### **Wollongong Local Planning Panel Assessment Report** | 23 February 2023

WLPP No.	Item No.3
DA No.	DA-2022/320
Proposal	Residential - demolition of existing structures, construction of 9 storey building consisting of 35 units, basement parking, swimming pool and associated communal spaces
Property	17-19 Gladstone Avenue, Wollongong
Applicant	Design Workshop Australia
Responsible Team	Development Assessment and Certification - City Centre Major Development Team

#### ASSESSMENT REPORT AND RECOMMENDATION

DRAWING NAME: PROPOSED BUILDING 3D VIEWS

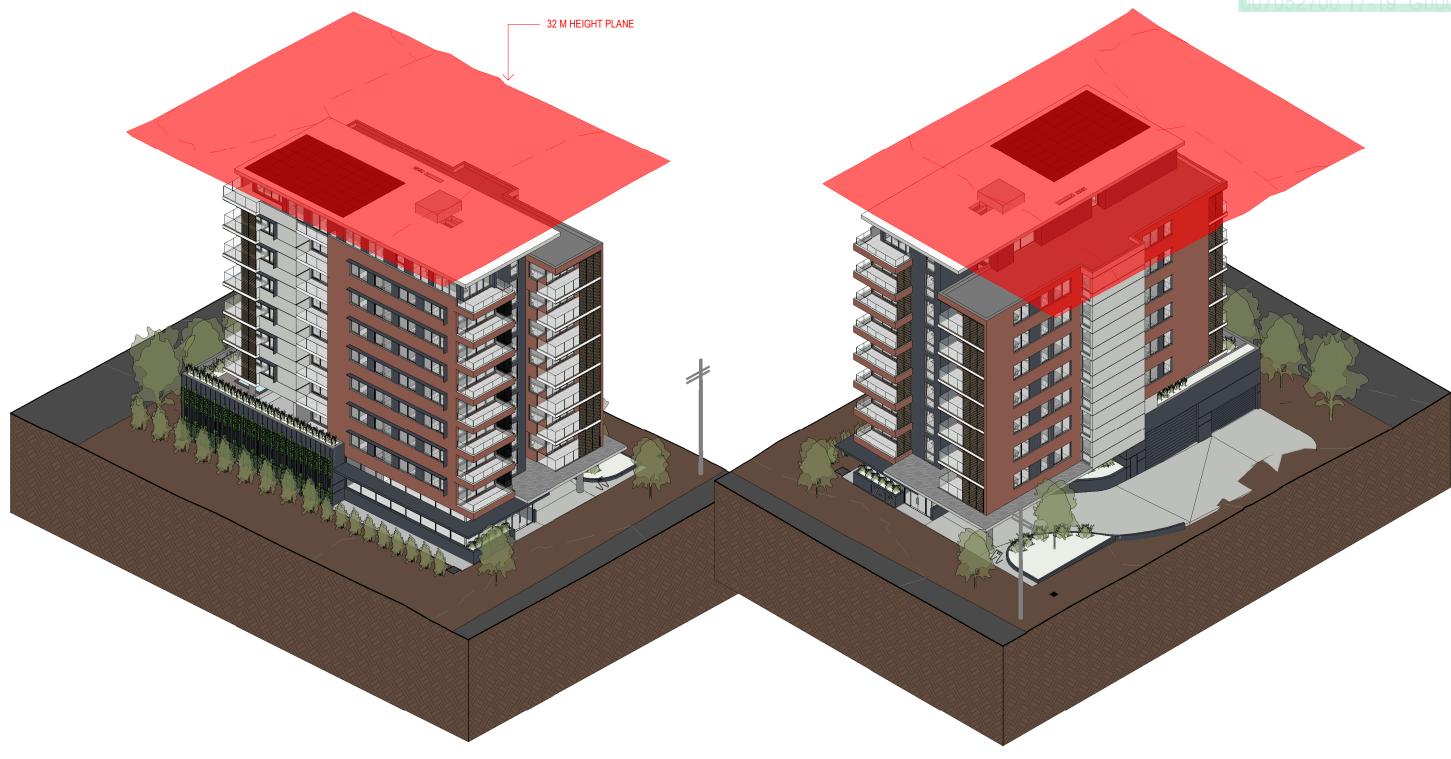
Aesthetics	It is envisaged that the form of this proposal may develop further in response to issues raised in this report. Material selection documented in drawing 082, Proposed Building 3D views, documents an appropriate pallet of materials for this context.	The ground plane has improved to provide a more active interface with Gladstone Avenue, given the constraints.

It is envisaged that the form of this proposal may develop further in response to issues raised in this report. Material selection documented in drawing 082, Proposed Building 3D views, documents an appropriate pallet of materials for this context.
